In support of comment I-95 to change average launch power max

September 22nd, 2020

FR4 Receiver Performance vs ER

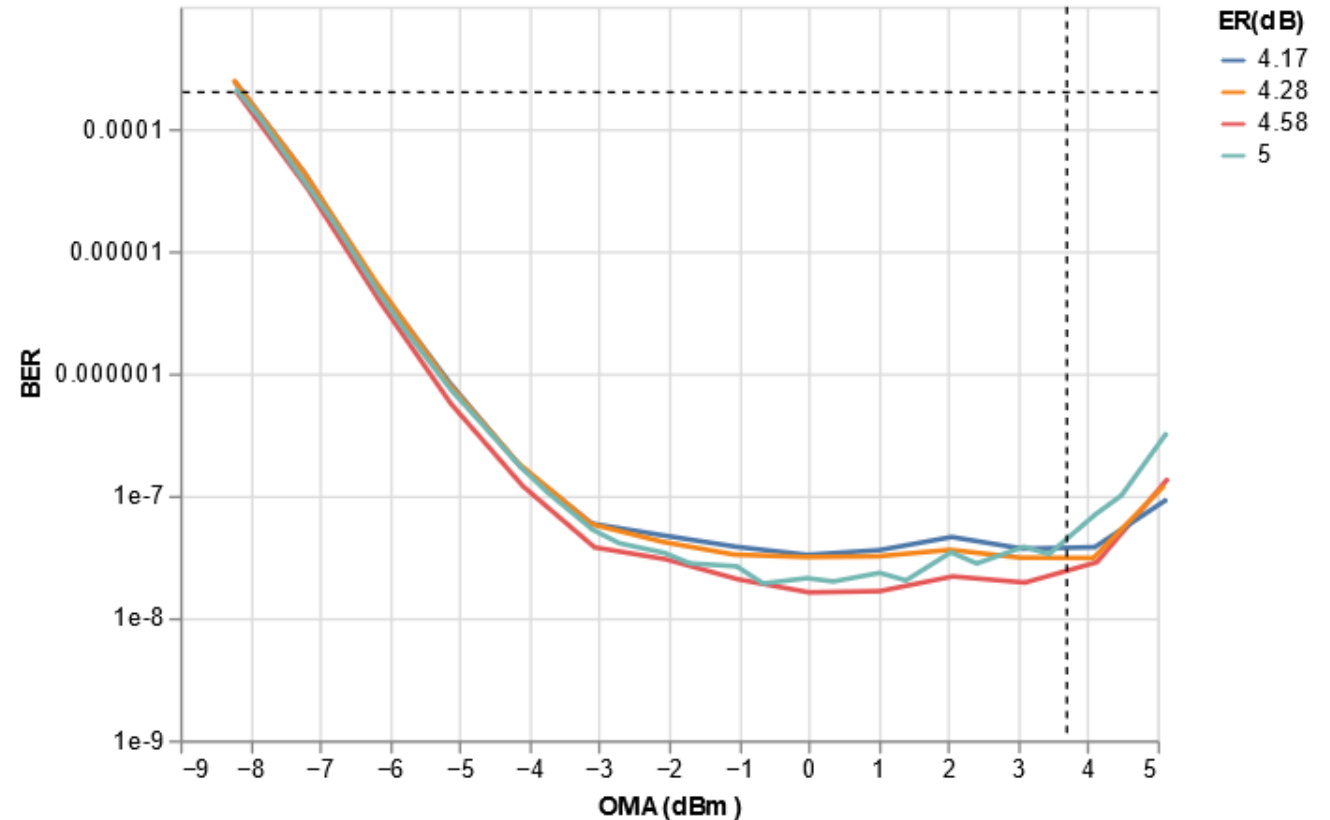
- ❑ Measuring waterfall on same receiver and transmitter adjusting Tx swing to vary ER.
- ❑ Lowest ER line has 0.68dB higher AOP than the highest ER at the same OMA
- ❑ Higher AOP on the lowest ER does not trigger overshoot at lower OMA
- ❑ Receiver overload is affected by OMA, not AOP

- ❑ We recommend increasing Average launch power max spec to 0.7 dB higher than Outer Optical Modulation Amplitude max spec:
 - ❑ 4.4dB for FR4 and 5.1dB on LR4-6
